Planning and Zoning Board Agenda July 9, 2019

- A. Approval of the Minutes of the June 11, 2019 PZB Meeting
- B. Site Plan - Alchem Building Three: A request by Caitlyn Drane, P.E. of eda engineers-surveyors-

- C. Site Plan - Innovation One: A request by Alison Fetner, P.E., of Fetner Engineering, applicant and agent for Shoppes at Progress Center, LLC, property owner, for consideration of a Site Plan to construct a ±30,676 square foot light manufacturing (research and development) facility, with associated paving, grading, drainage, landscaping and infrastructure improvements, on a ±2.80 acre subject property, located southwest of the intersection of US Highway 441 and Progress Boulevard, and north of Research Drive and UF Innovate | Sid Martin Biotech; Tax Parcel Number 03956-010-027 (Quasi-Judicial Hearing).

SUBJECT: Site Plan - Alchem Building Three: A request by Caitlyn Drane, P.E. of eda engineers-surveyors-planners, inc., applicant and agent for James D. Talton of Alchem Laboratories Corporation, property owner, for consideration of a Site Plan to construct a ±12,000 square foot light manufacturing facility, with associated paving, grading, drainage, landscaping and infra

AC&D File Name		Project:		Sheet Scale: 1" = 30'		Approved By:	
				Project No:		Title:		Sheet Scale: n/a			
				19-06						ALISON FETNER, PE 44669	
				C-2		UTILITY PLAN		Date:			
								JAN, 2019

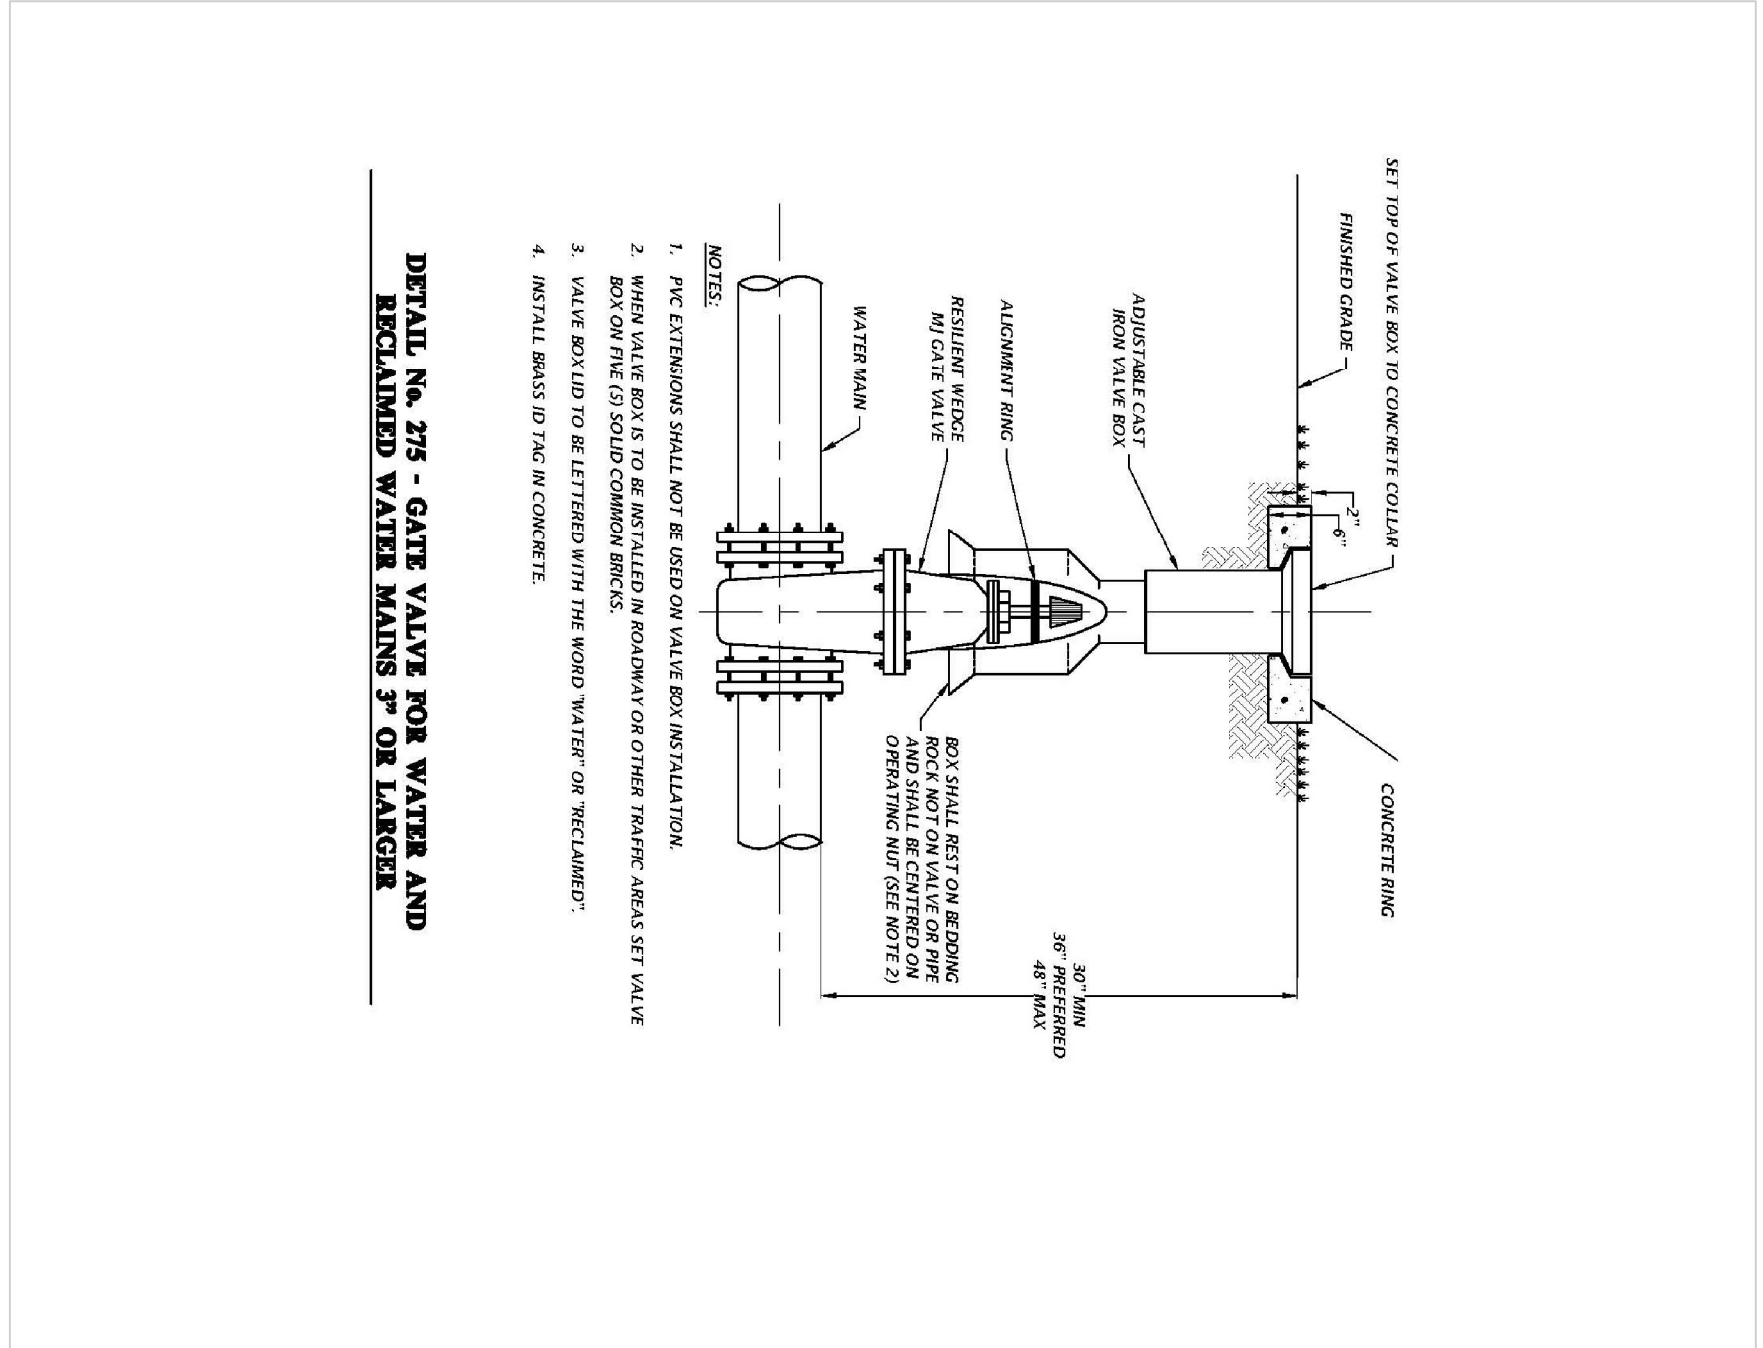
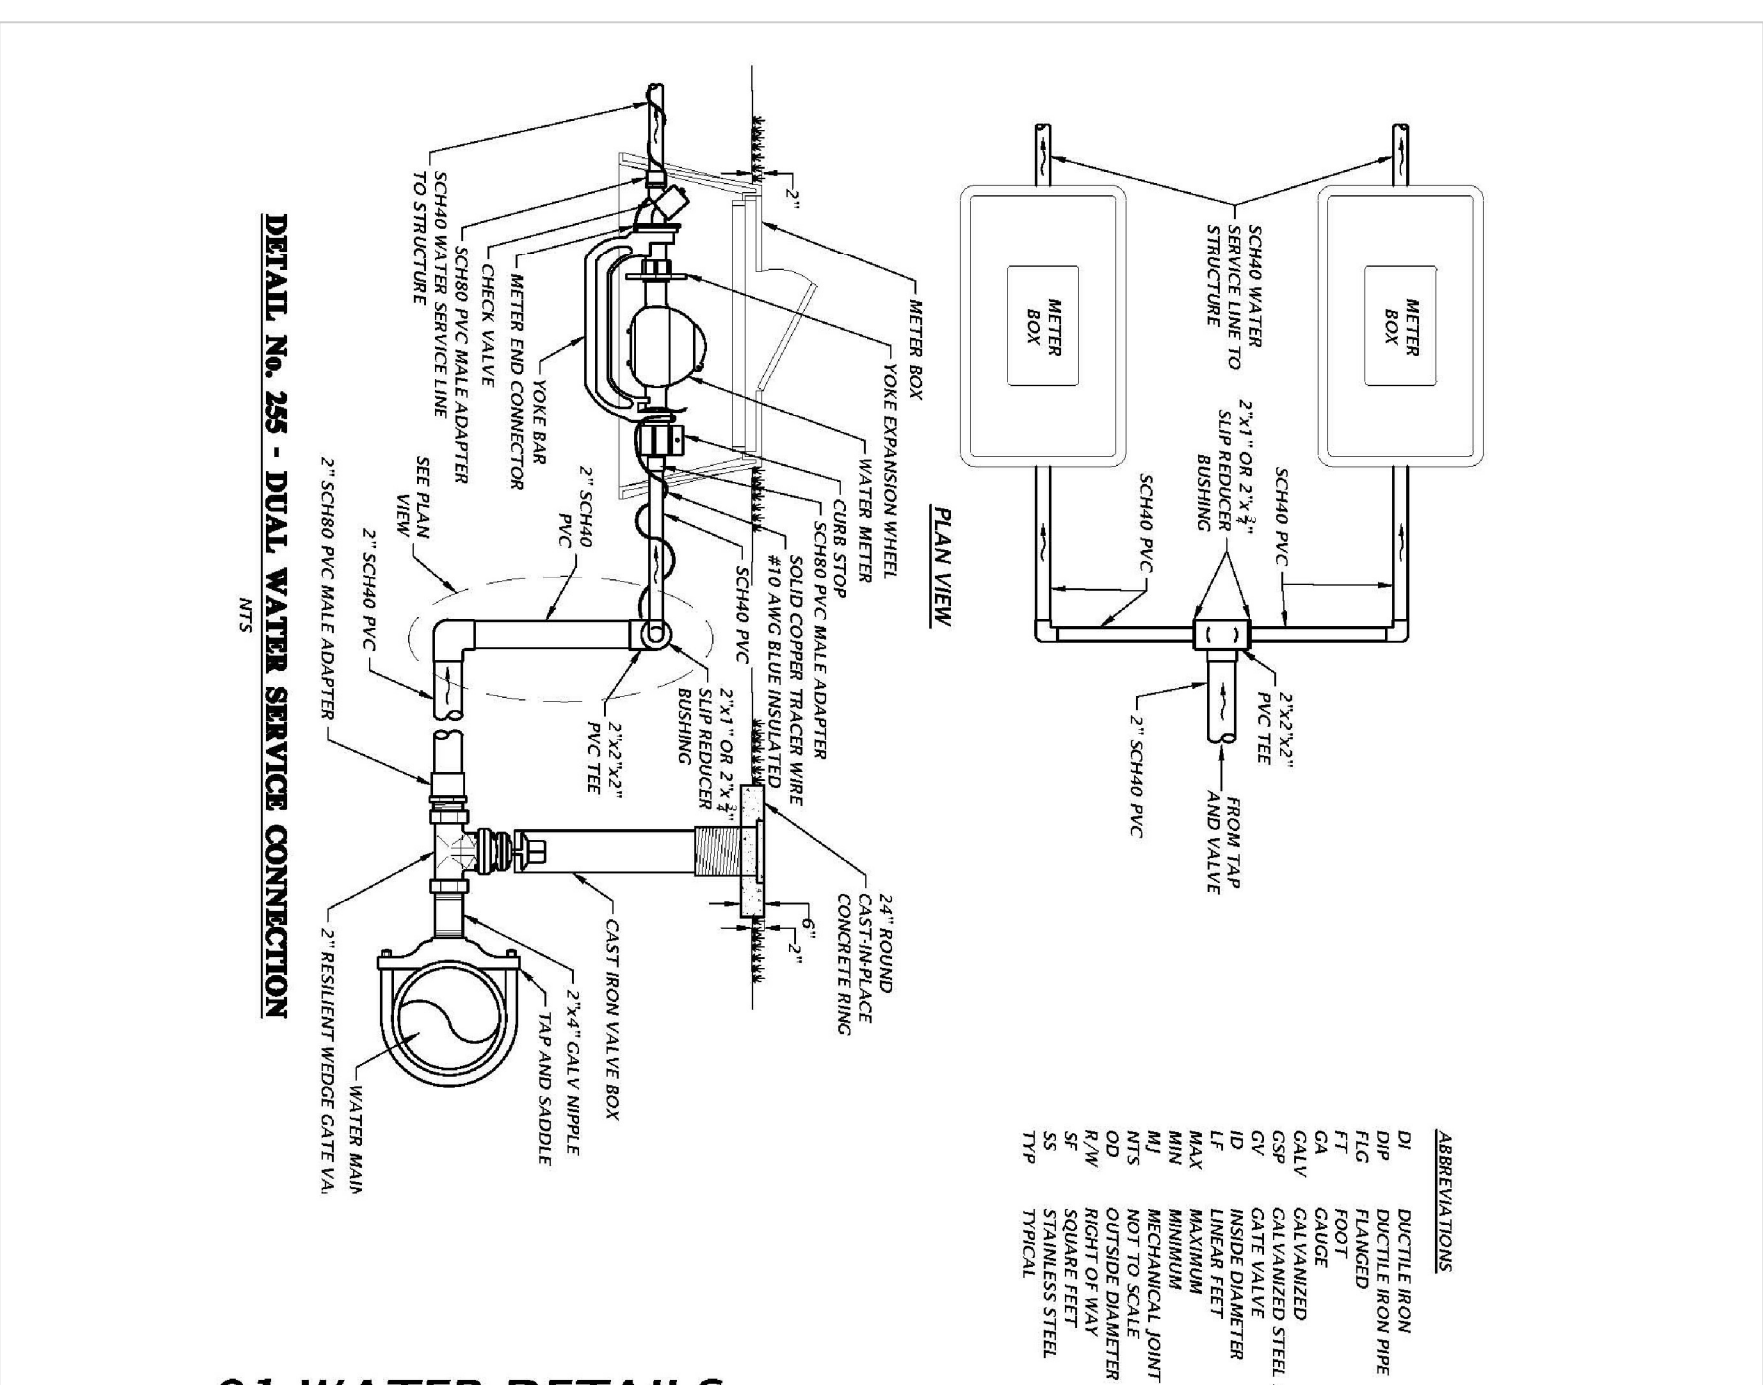
Sheet C-2 Utility Plan, Fire Line and Ganged Water Meters

As now shown there is one common RPZ backflow preventer for the fire line and ganged water meters. Please provide individual RPZ backflow preventers and isolation valves for the fire line and ganged water meters. For the ganged water meters, suggest using Detail 240 – please add to C-3.

4.	Sheet I, Survey Add sheet number and title to this sheet. [Approved as Noted] Comments for April 29th Submittal Approved.
5.	Sheet C-2, Utility Plan - A 4-inch lateral line (just below text “Terminus of 4-inch PVC fire protection line” appears to be missing a segment. Please add. - Add leader to text “4-inch PVC lateral (type)”. - Last page of report indicates that an on-site dumpster will be provided. Please call out this dumpster. - A 4-inch backflow preventer (BFP) is shown in the water line. Please add a detail for this BFP in detail sheet(s). - A segment of the 1-inch water line runs underneath the road. Is there any way to reroute it so its route under the road is minimized. - Please confirm that no electrical work is part of this project. [Revise and Resubmit] Comments for April 29th Submittal Approved.

6.	Sheet C-2, Utility Plan - Show easements for City maintained facilities. - Cleanouts (wastewater) and water meters are shown just south the proposed building. These components will need to be accessed by City staff once construction is complete. Locate City utilities (i.e. wastewater cleanout and water meter) within the Public Utility Easement (PUE). - The reviewer assumes this PUE is south of the “Northerly Right of Way Line- Research Drive”, Sheet S-1. Please confirm. - Locating these components in the PUE will require that pipe routing be changed for both water and wastewater. [Revise and Resubmit]

NO.	COMMENTS
4.	Sheet 1, Survey Add sheet number and title to this sheet. [Approved as Noted]
5.	Sheet C-2, Utility Plan • A 4-inch lateral line (just below text "Terminus of 4-inch PVC fire protection line" appears to be missing a segment. Please add. • Add leader to text "4-inch PVC lateral (type)". • Last page of report indicates that an on-site dumpster will be provided. Please call out this dumpster. • A 4-inch backflow preventer (BFP) is shown in the water line. Please add a detail for this BFP in detail sheet(s). • A segment of the 1-inch water line runs underneath the road. Is there any way to reroute it so its route under the road is minimized. • Please confirm that no electrical work is part of this project. [Revise and Resubmit]

6.	Sheet C-2, Utility Plan • Show easements for City maintained facilities. • Cleanouts (wastewater) and water meters are shown just south the proposed building. These components will need to be accessed by City staff once construction is complete. Locate City utilities (i.e. wastewater cleanout and watermeter) within the Public Utility Easement (PUE). • The reviewer assumes this PUE is south of the "Northerly Right of Way Line- Research Drive", Sheet S-1. Please confirm. • Locating these components in the PUE will require that pipe routing be changed for both water and wastewater. [Revise and Resubmit]
